**APPLICATION FOR
SPECIAL PERMIT AND SITE PLAN APPROVAL
(Planning Board)
And
VARIANCES
(Zoning Board)
FOR
PERSONAL WIRELESS SERVICE FACILITY

SUPPLEMENT No. 1**

Applicant: Vertex Towers, LLC
Site Id: VT-MA-0019F
Property Address: 26 Martin Road, Buckland, MA 01338
Tax Assessors: 8-0-60 (facility)
8-0-60.1 (access)
Property Owner: Amos M. Franceschelli and Christopher Franceschelli
Date: May 13, 2022

Reference is made to the letter of the Buckland Planning Board dated April 21, 2022 with respect to the above referenced Application.

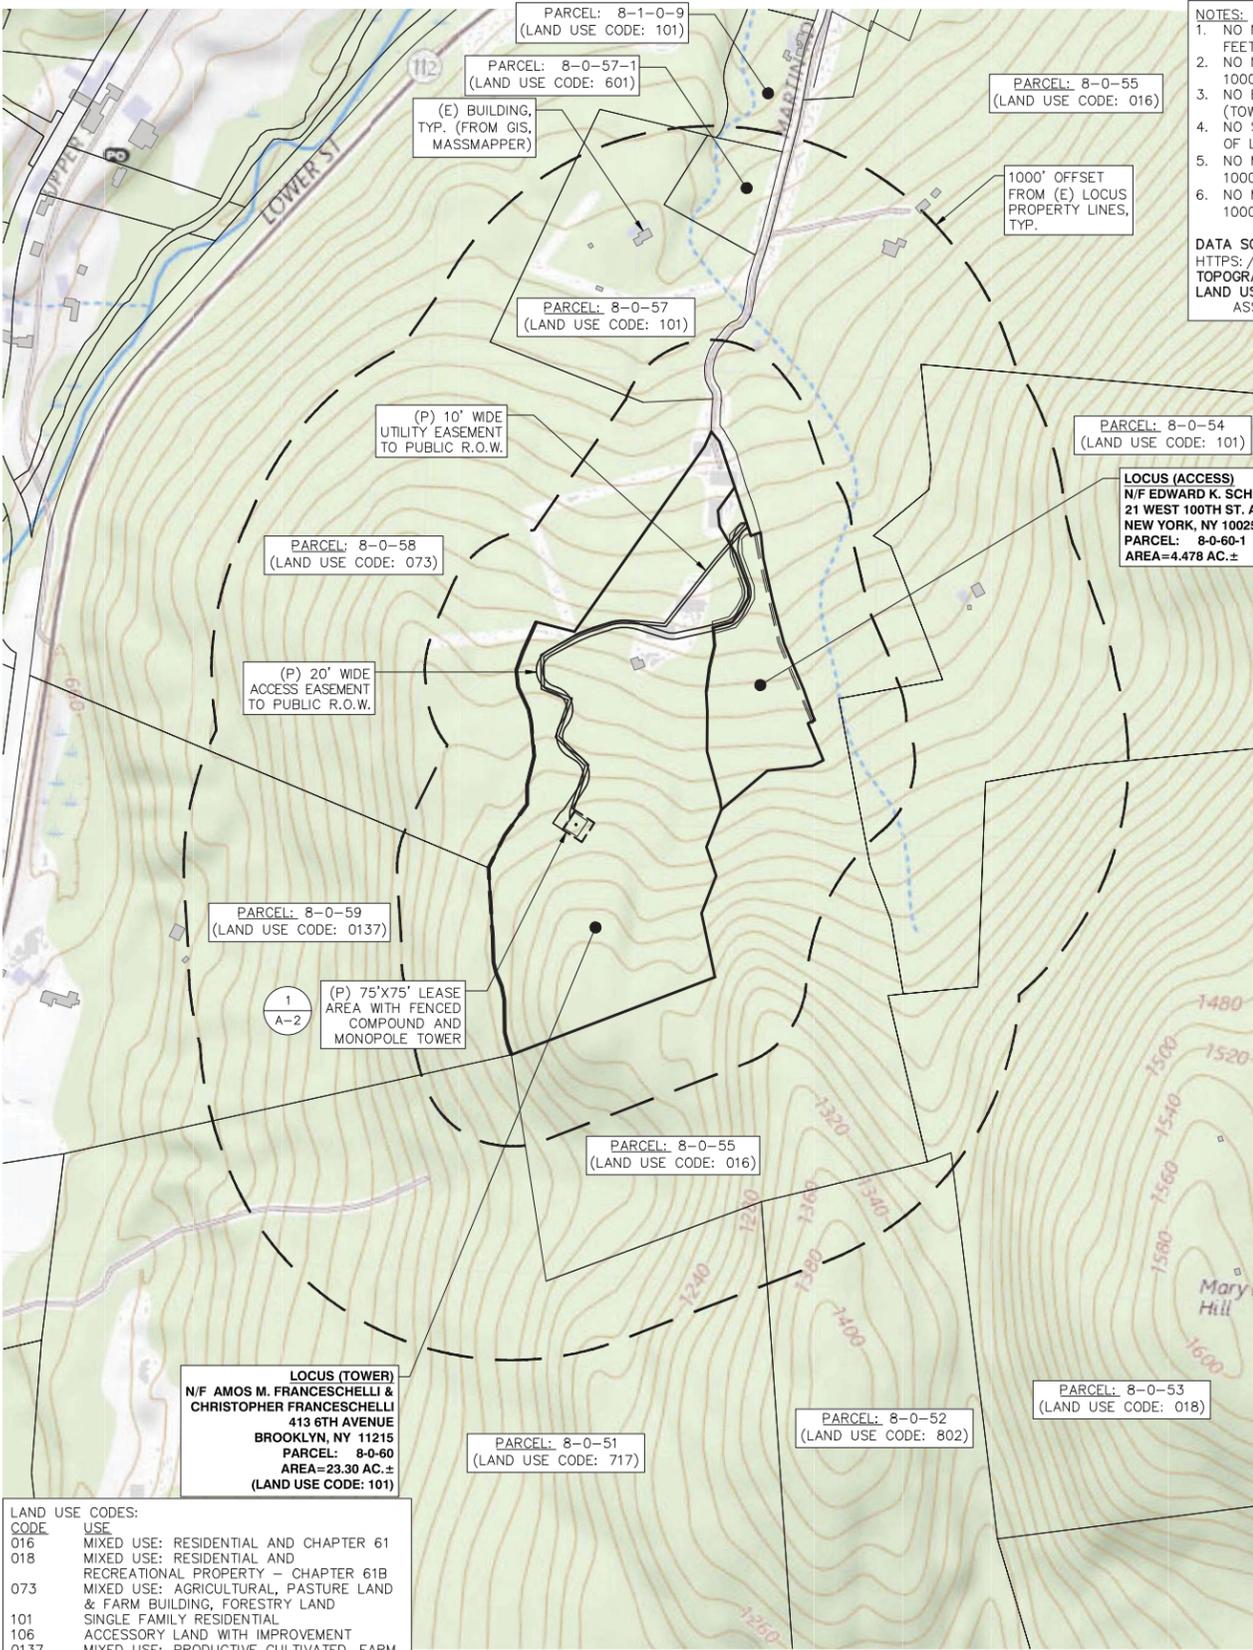
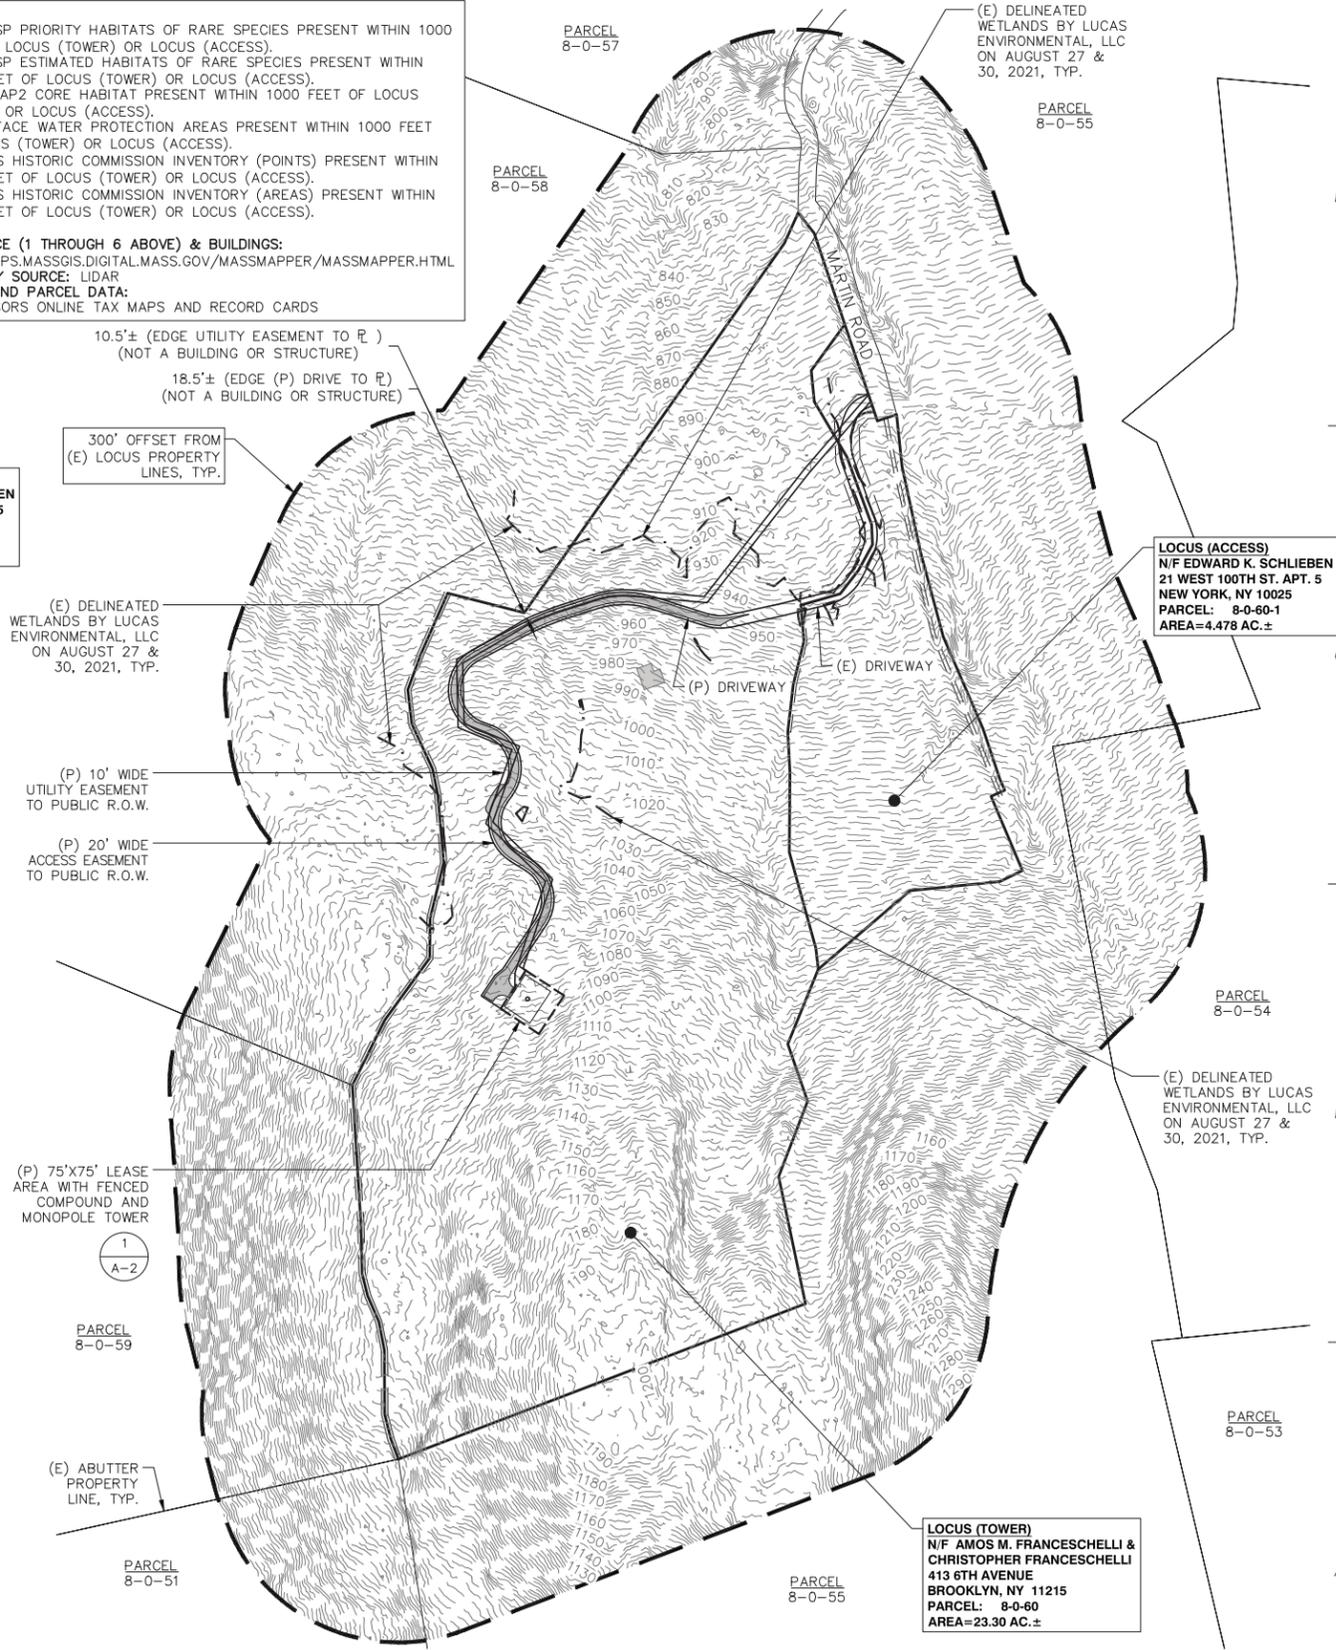
(6) A locus map, utilizing the most recent U.S.G.S. topographic maps of the area, which shall show all streets, bodies of water, historic sites, habitats for endangered species within 1000 feet, and all buildings within 1000 feet.”

Please provide items (3) and (6) or provide statements as to why they are not necessary or applicable. For item (5) please provide any information that may be available currently about “future” facilities in Buckland.

Supplemental Site Plan Sheet SP-2 shows all lot lines of the subject parcel and properties within 1000 feet, utilizing USGS Topographic maps, as well as buildings from GIS and land uses per Town Assessment. Per Massachusetts State MASSMAPPER GIS, no areas of NHESP habitat (or estimated habitat) for rare species are present within 1000 feet of the locus parcels, nor are there any Historic sites, per GIS within 1000 feet as well. A note is included in Supplemental Site Plan SP-2 regarding these resources.

Section 5-2 regulates the setback requirements of structures on the property. Utility poles and access drives are not subject to these setback requirements, and the compound and tower clearly required setbacks as shown on the Site Plan. However, the requested distances are shown on Supplemental Site Plan Sheet SP-2, detail 2 “Overall Topography Plan”.

- NO NHESP PRIORITY HABITATS OF RARE SPECIES PRESENT WITHIN 1000 FEET OF LOCUS (TOWER) OR LOCUS (ACCESS).
- NO NHESP ESTIMATED HABITATS OF RARE SPECIES PRESENT WITHIN 1000 FEET OF LOCUS (TOWER) OR LOCUS (ACCESS).
- NO BIOMAP2 CORE HABITAT PRESENT WITHIN 1000 FEET OF LOCUS (TOWER) OR LOCUS (ACCESS).
- NO SURFACE WATER PROTECTION AREAS PRESENT WITHIN 1000 FEET OF LOCUS (TOWER) OR LOCUS (ACCESS).
- NO MASS HISTORIC COMMISSION INVENTORY (POINTS) PRESENT WITHIN 1000 FEET OF LOCUS (TOWER) OR LOCUS (ACCESS).
- NO MASS HISTORIC COMMISSION INVENTORY (AREAS) PRESENT WITHIN 1000 FEET OF LOCUS (TOWER) OR LOCUS (ACCESS).
